PLANNING COMMISSION MEETING

4.A. PC Case 20-04 – Site Plan, Preliminary And Final Plat Review To Allow A Climate Controlled Storage Building At 1665 Oakdale Ave. – More Space LLC

To: **Planning Commission**
From: **Melissa Sonnek, City Planner**
Date: **May 19, 2020**

Site Plan, Preliminary, & Final Plat for 1665 Oakdale Ave – More Space LLC

Engineering/Stormwater Review

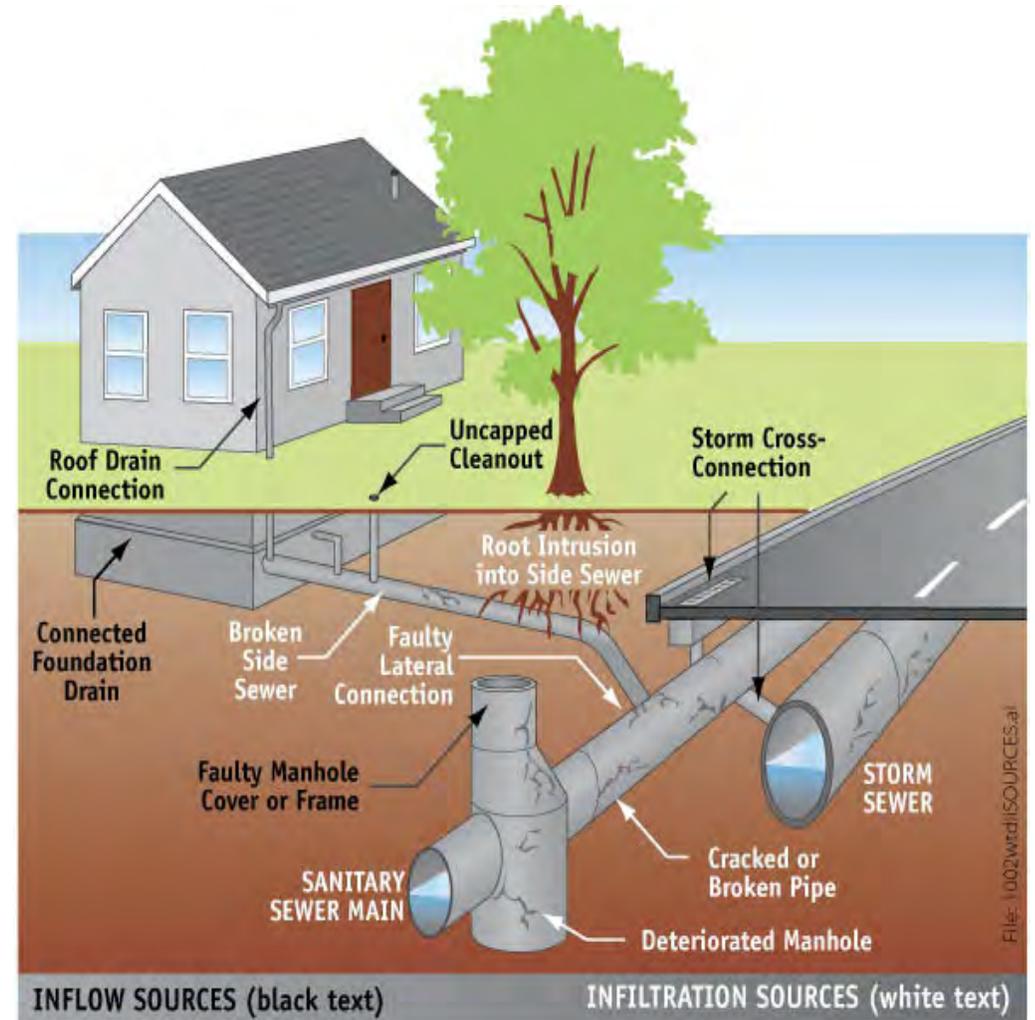
The submitted plans were reviewed by an engineering consultant,

- All development disturbing more than one acre of land must submit a stormwater management plan.

The engineering consultant recommended a number of conditions pertaining to:
